UNITED STATES PATENT AND TRADEMARK OFFICE

APPLICATION NO.	FILING DATE	FIRST NAMED INVENTOR	ATTORNEY DOCKET NO.	CONFIRMATION NO.
10/619,928	07/15/2003	Richard A. Terwilliger	WORLD-01000USB	6815

Office Action Summary

DETAILED ACTION

Figure 1).

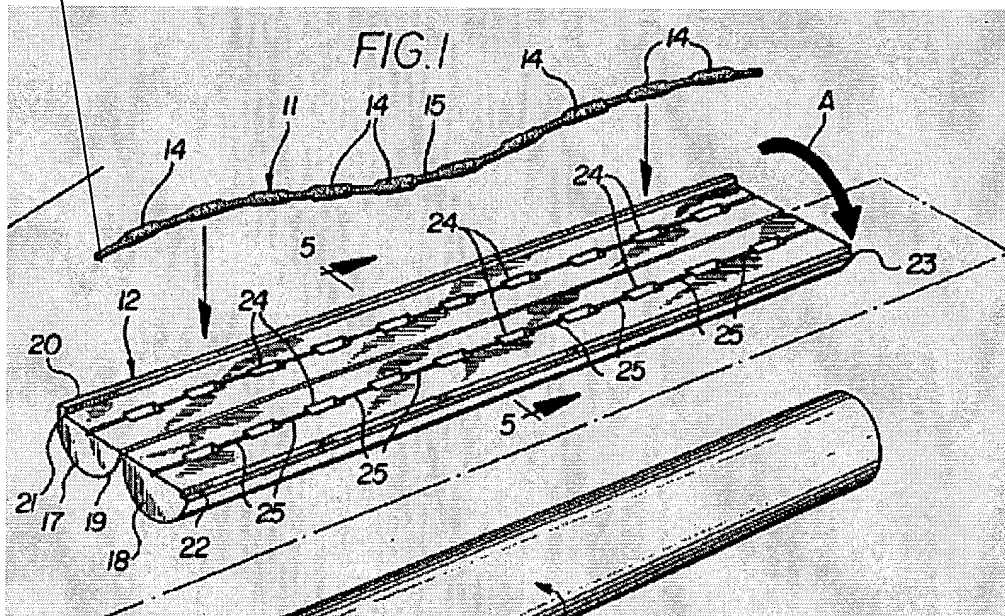
9. Claim 14 is rejected under 35 U.S.C. 102(b) as being anticipated by Langton et al. (US 5,460,592) cited by Applicant. Langton et al. ('592) teach a therapeutic device comprising: a seed strand having a length with a distal end [see Figure 1(11)]; a plurality of seeds provided along the length of the strand [see Figure 1(14)]; the seeds being provided at spaced intervals along the length of the strand [see Figure 1(15)]; and a custom end space provided between the seed located adjacent to the distal end and the distal end of the strand (see
